## **NATIONAL AERONAUTICS AND SPACE ADMINISTRATION (NASA)**

**National Environmental Policy Act (NEPA);** Reconfiguration of the Wallops Flight Facility (WFF) Main Entrance

**ACTION:** Finding of No Significant Impact (FONSI)

Appendix B...Comments Received on Main Gate Reconfiguration Project Draft Environmental  
Assessment and NASA Response Matrix

**Figure 1-5: 150 percent increase in vehicular traffic at WFF main entrance**

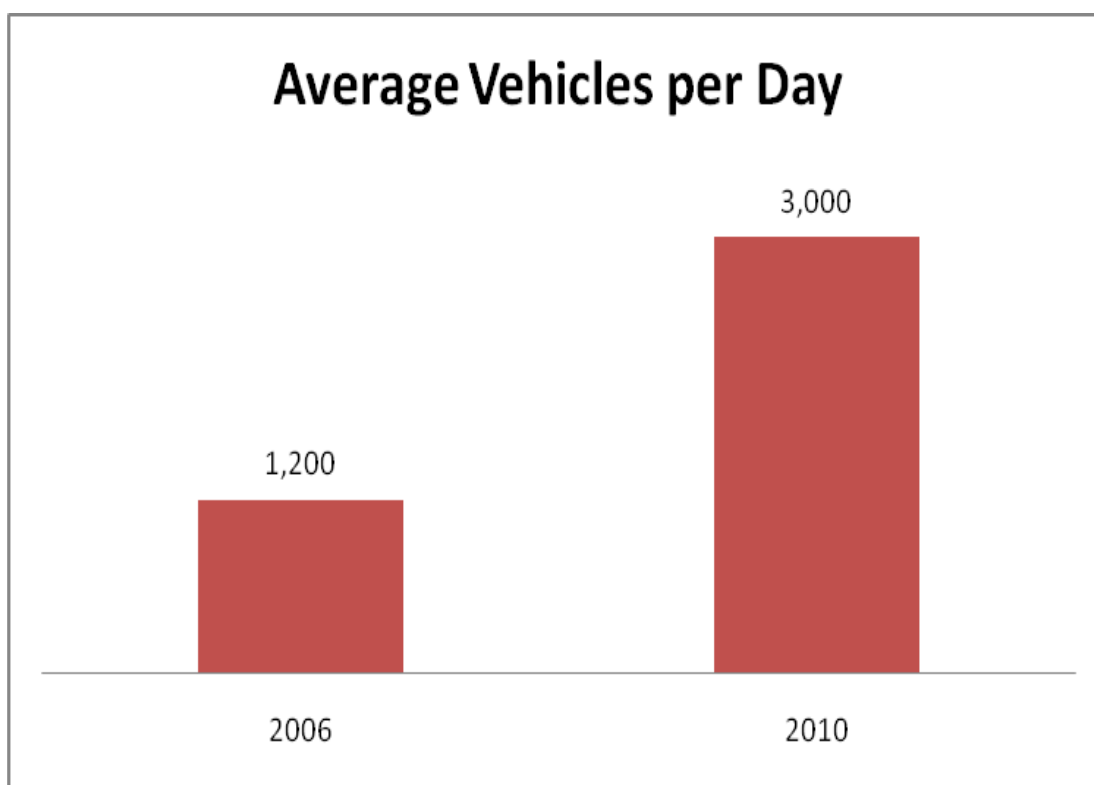
RESPONSE-In 2010, there were 3000 vehicles/day at the main entrance. Access to the main gate is by Atlantic Road or Mill Dam Road. Both are two lane roads with Mill Dam having more of the traffic. If the alternative site is used, then Mill Dam travelers needing a pass or inspection must also use Atlantic Road. Doesn't this definitely increase congestion and use of Atlantic Road. Also see Fig 1-5 that shows 37,635 requests for temporary badges in 2010.

**Figure 2-12: Alternative One badge office site, facing east**

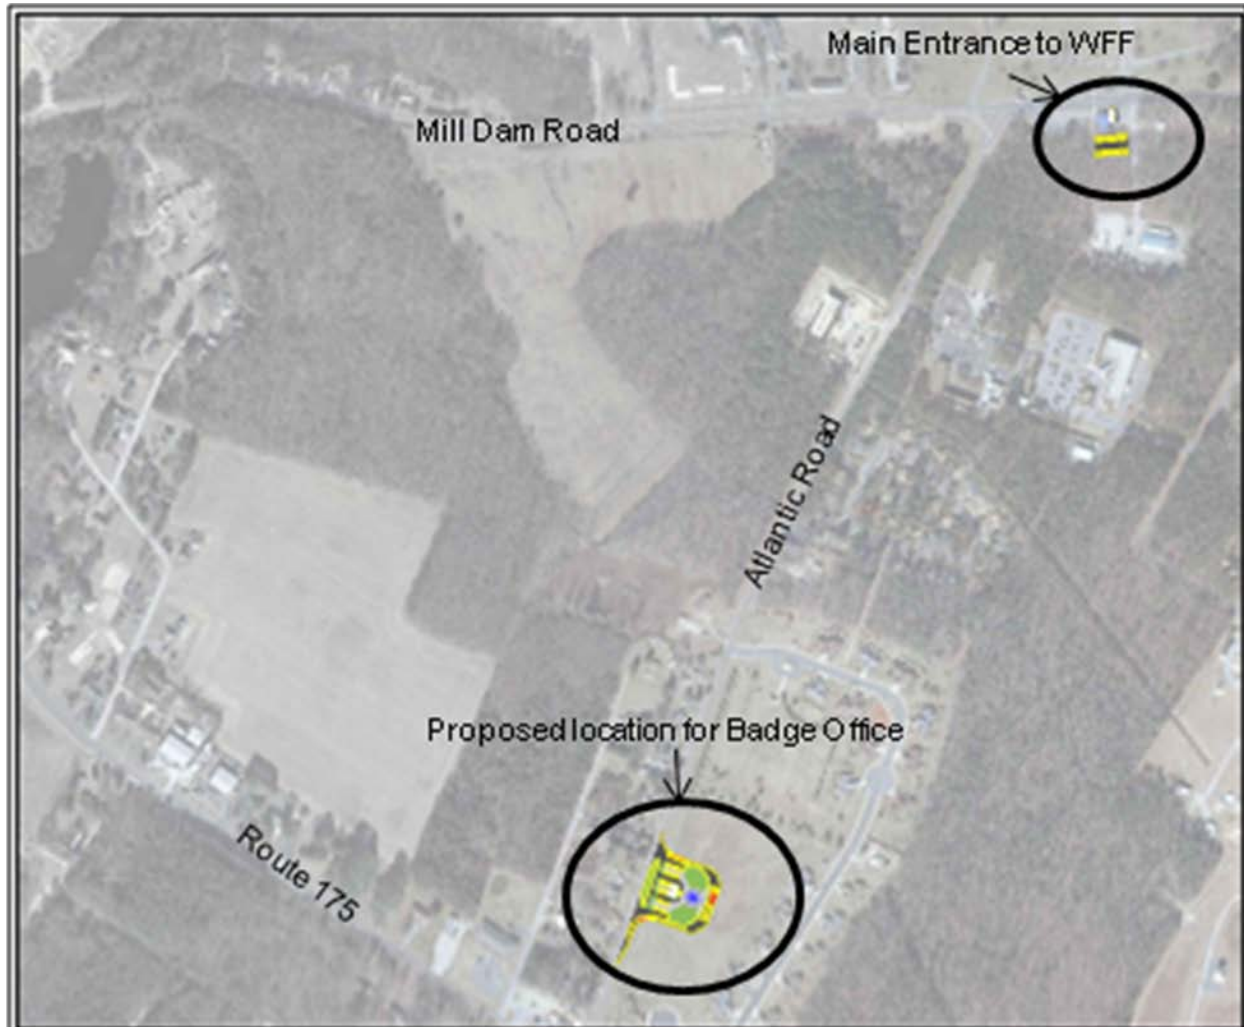
RESPONSE-Fig 2-12. Civilian housing refers to the residential houses on the other side of Atlantic Road. I question the 300 feet distance. Really! One football field distance would separate the nearest house on Atlantic Road from the facility. The houses along Atlantic Road are not 300 feet from the NASA fence and that is where the vehicles have to enter. 150 feet would be more accurate. Yes the impacts would be moderate at best and long term for sure.

9	Fig 2-12: Civilian housing refers to the residential houses on the other side of Atlantic Road. I question the 300 feet distance. Really! One football field distance would separate the nearest house on Atlantic Road from the facility. The houses along Atlantic Road are not 300 feet from the NASA fence and that is where the vehicles have to enter. 150 feet would be more accurate. Yes the impacts would be moderate at best and long term for sure. What happened to the vehicle inspection area?	The distance presented was to the badge office building, not to the entrance of Alternative One. Please refer to the "NASA Response" column for Comment No.4 regarding the location of POV inspections.	Added language to Section 3.1.1.2 to clarify the distance.
10	Paragraph 2 acknowledges that traffic noise would increase in the residential area.	Comment noted.	No change required.
11	Keep in mind that the dB scale is a log scale so what seems to be small scale differences	Please note that the "Possible Effects on Humans" column header on Table 3-10 contains a	No change required.
